# STORMWATER SITE PLAN REPORT

## FARM 12 – PARKING LOT REVISION

C&A PROJ # 25-018

NOVEMBER 18, 2025  
PERMIT #PRCCP20241731

C4.00

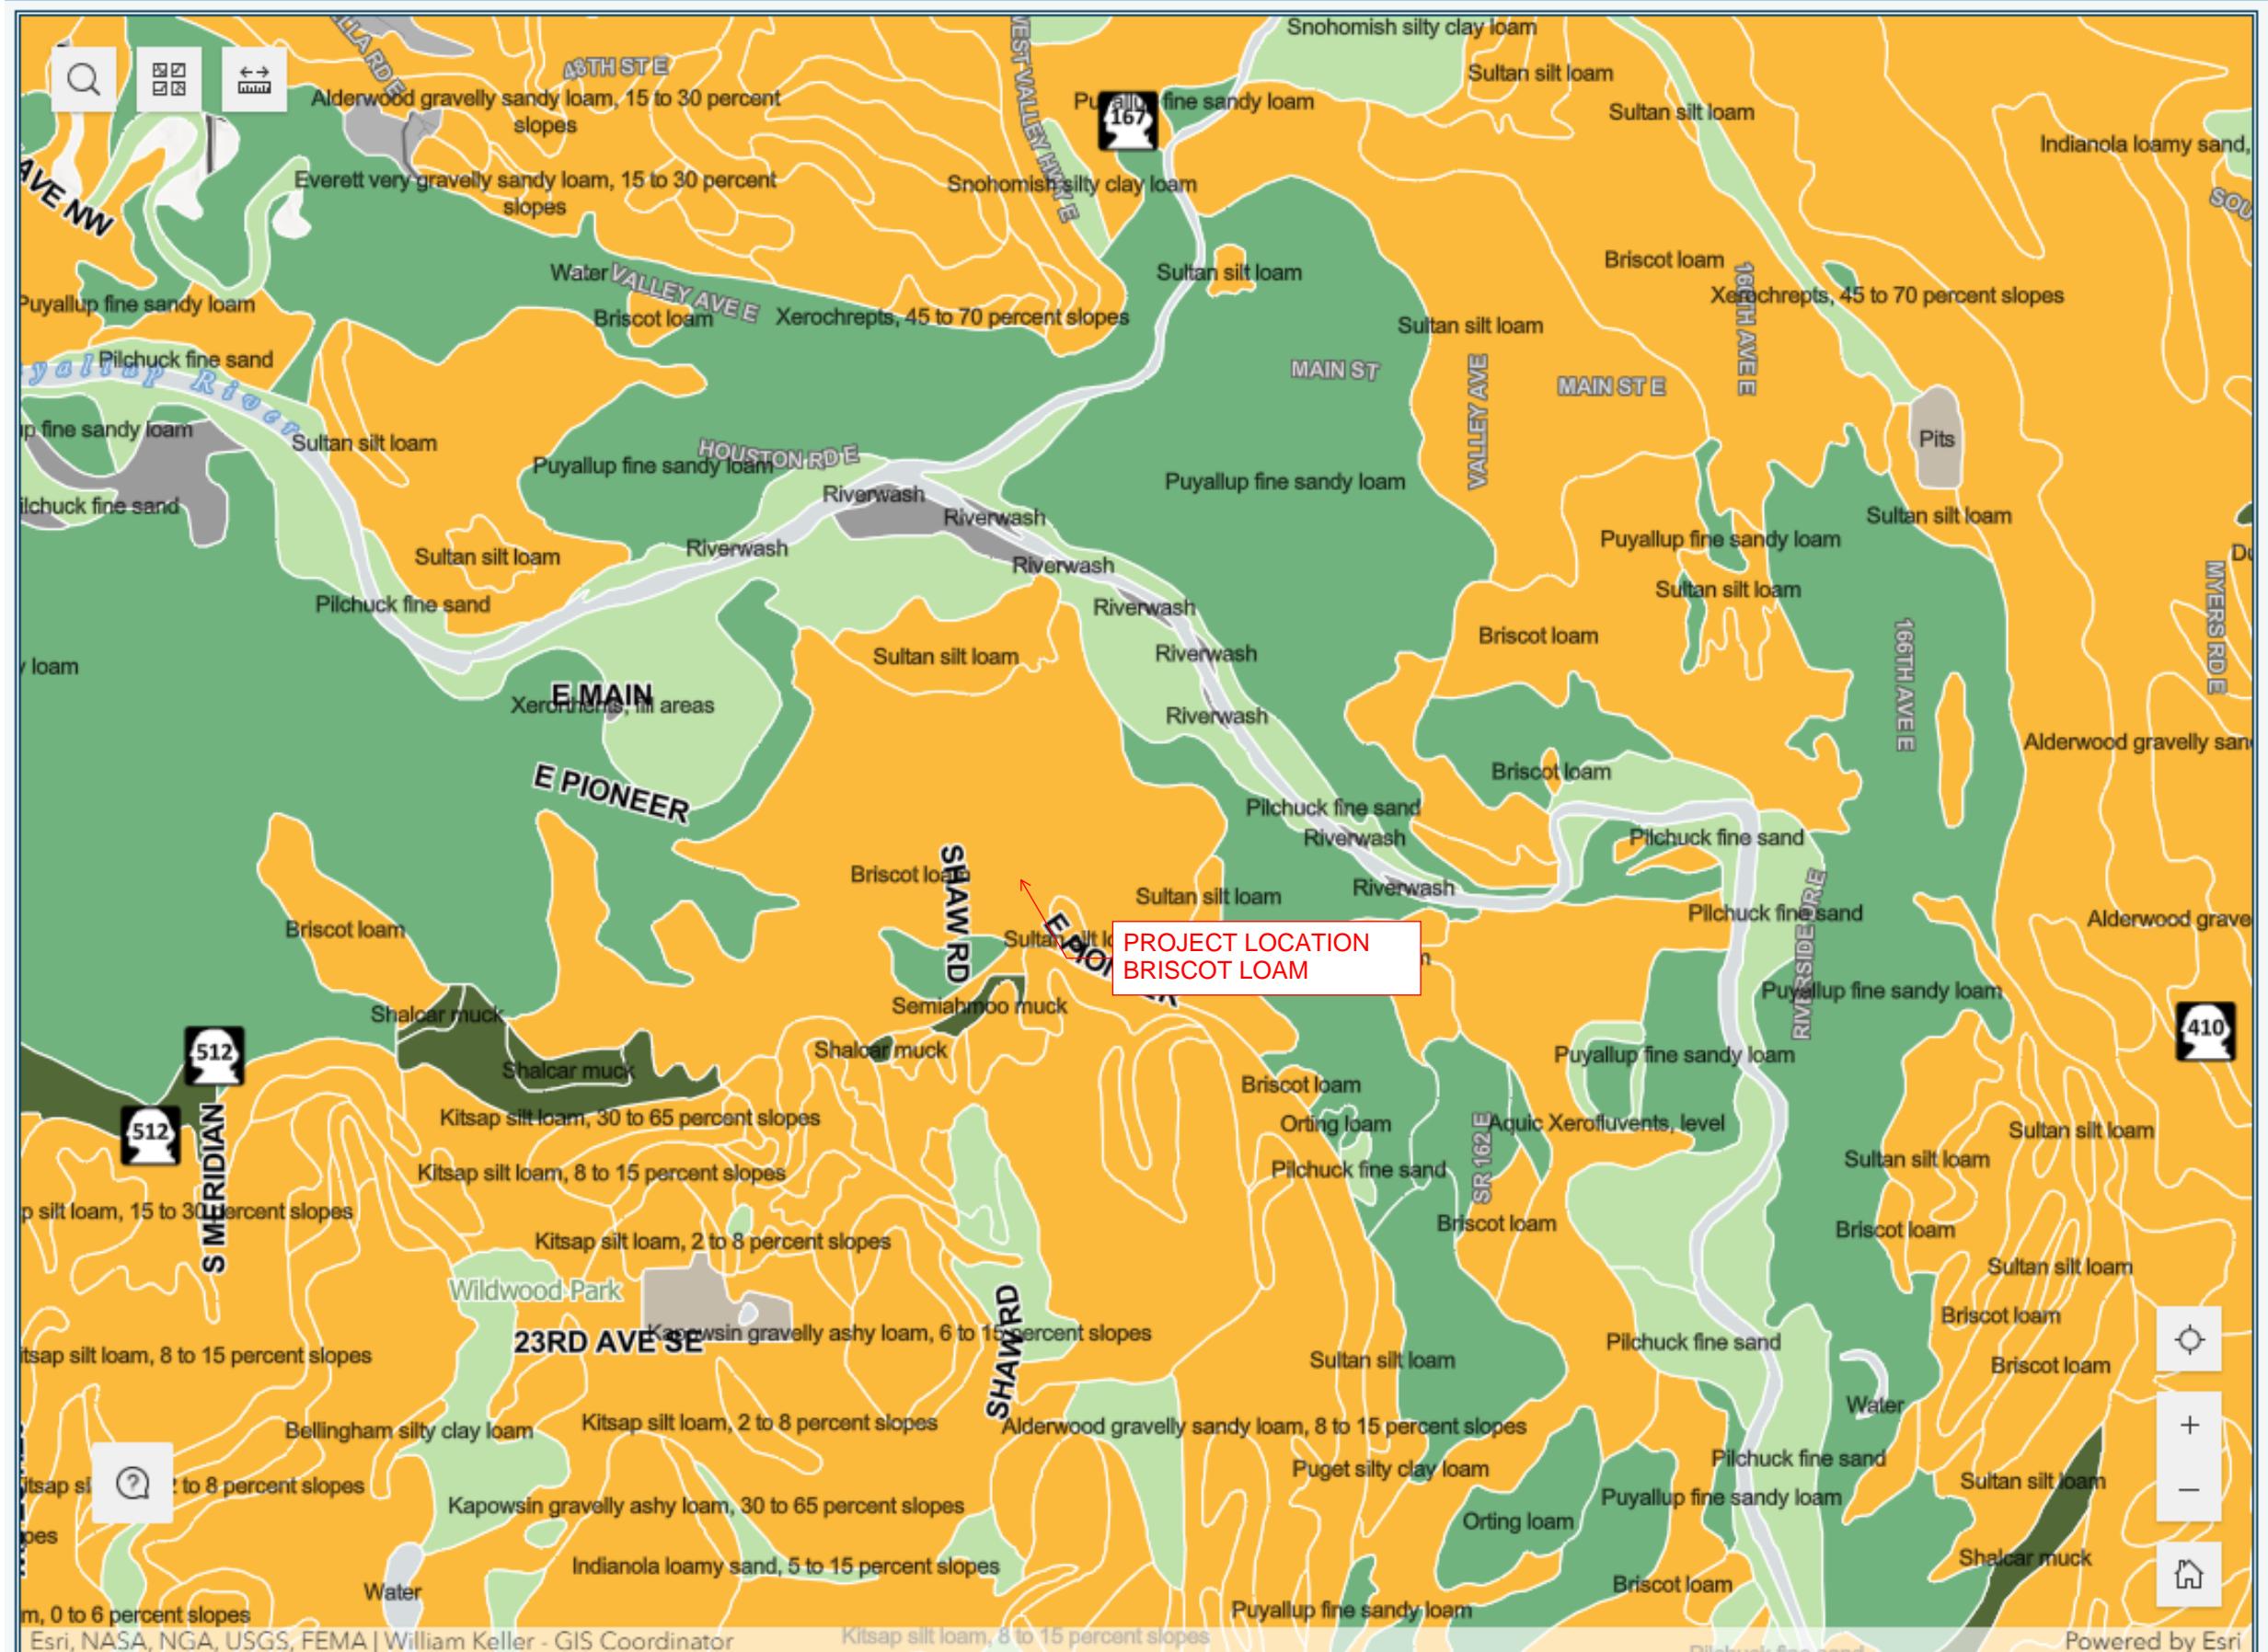
Verify-35ft req'd? (68ft\*10/20)

Verify-7,400sf (0.17ac)?
